Monticello Nuclear Generating Plant  
Docket No. 50-263  
Renewed Facility Operating License No. DPR-22

Part 3 Response to Probabilistic Risk Assessment (PRA) Related Requests for Additional Information: License Amendment Request for a Permanent Extension of the 10 CFR 50 Appendix J Containment Type A Test Interval (CAC No. MF7359)

**PART 3 RESPONSE TO PROBABILISTIC RISK ASSESSMENT (PRA) RELATED  
REQUESTS FOR ADDITIONAL INFORMATION**

**LICENSE AMENDMENT REQUEST FOR A PERMANENT EXTENSION OF  
THE 10 CFR 50 APPENDIX J CONTAINMENT TYPE A TEST INTERVAL**

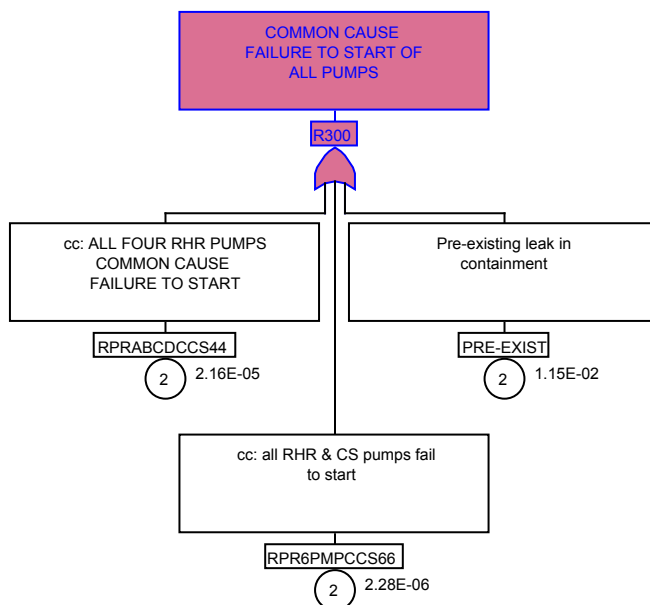
- b. **If an updated analysis is performed, describe this analysis and justify why it is sufficient to evaluate the risk due to the containment accident pressure for the application.**

The second step in the analysis is to add a new basic event to the MNGP PRA model to logically OR the pre-existing leak basic event with the low pressure ECCS pumps, such that the pumps are failed when the leak occurs. The basic event is logically ORed with the basic events that model a common cause failure of all Residual Heat Removal (RHR) and Core Spray pumps. An example is shown below:
